Board Staff Interrogatories
2013 Electricity Distribution Cost of Service Application
Brantford Power Inc.
EB-2012-0109
September 25, 2013

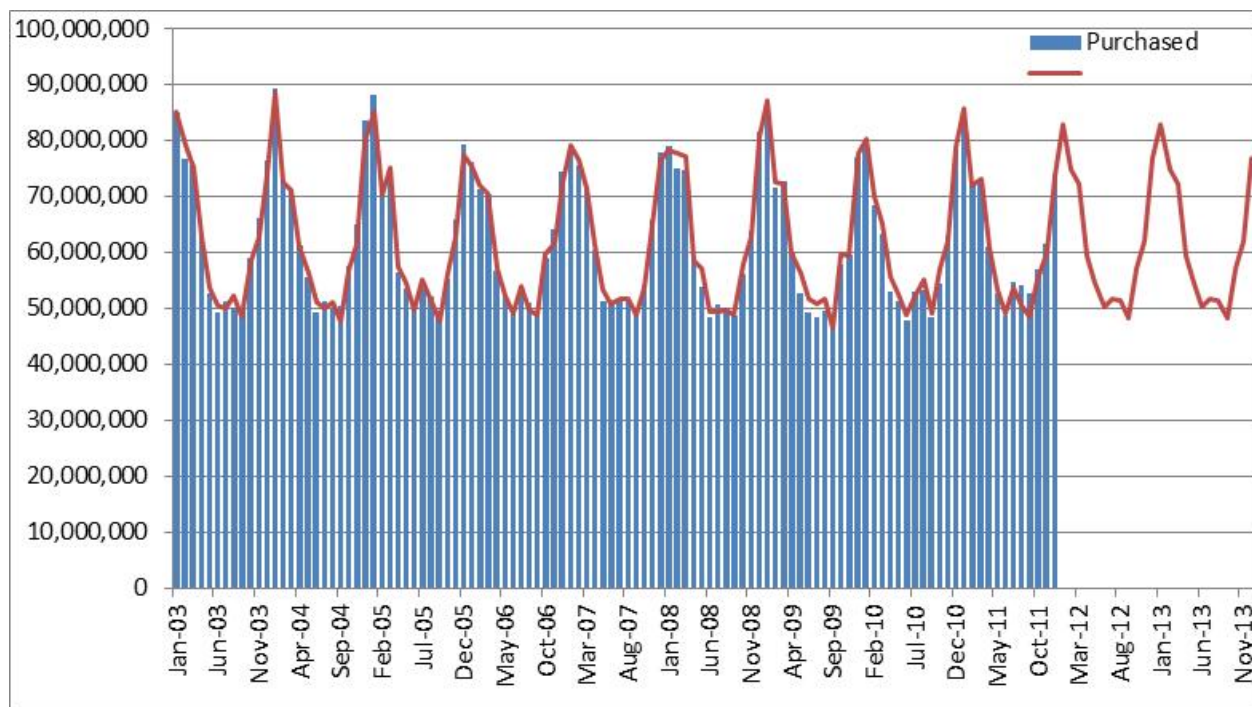
BPI has included a Negative Trend variable in its estimated regression equation, with the estimated coefficient of the CDM variable being -5.71. The data for the CDM/Negative Impact variable are contained in tab “CDM Activity” of the load forecast excel spreadsheet.

Analysis of the spreadsheet indicates that a linear interpolation was used to interpolate the monthly values to sum to the reported annual OPA savings in each year. As a starting example, the 2005 CDM savings per the OPA reports are 2,666,105 kWh in 2005. Board staff notes that, as documented in the OPA reports, the reported annualized savings for the year are estimated as if all programs were in effect the full year from January 1 to December 31.

New CDM programs are implemented at various times in the year and hence will not have the full impact in the first year of implementation. In recent Decisions, the Board has approved the application of the half-year rule as an approximation to measure the real impact of CDM programs in their initial year.

For example, the actual impact of 2005 CDM programs on 2005 consumption should be $2,666,105/2 = 1,333,053$ kWh. The monthly values in 2005 should be linearly interpolated from 0 such that the sum would equal the 1,333,053 kWh.

For 2006, the full annualized persistence of 2005 programs (i.e., 2,666,105 kWh) would be assumed, and the incremental annualized savings for 2006 should be divided by 2 to reflect the half-year impact of the 2006 CDM programs in the first year, 2006.

- Please prepare a CDM activity variable that reflects the half-year rule impact of CDM programs in the first year.
- Please re-run the regression model with this variable. Provide all regression statistics in the standard Microsoft Excel regression output format, and provide the regression model, including the construction of the CDM variable in this format.
- Please provide PBI's views on the reasonableness of the estimated CDM coefficient being greater than unity in absolute value.
- Please provide KWHI's views of the reasonableness of multiplying the persistence of 2011 CDM programs on the 2013 forecast by the CDM coefficient.
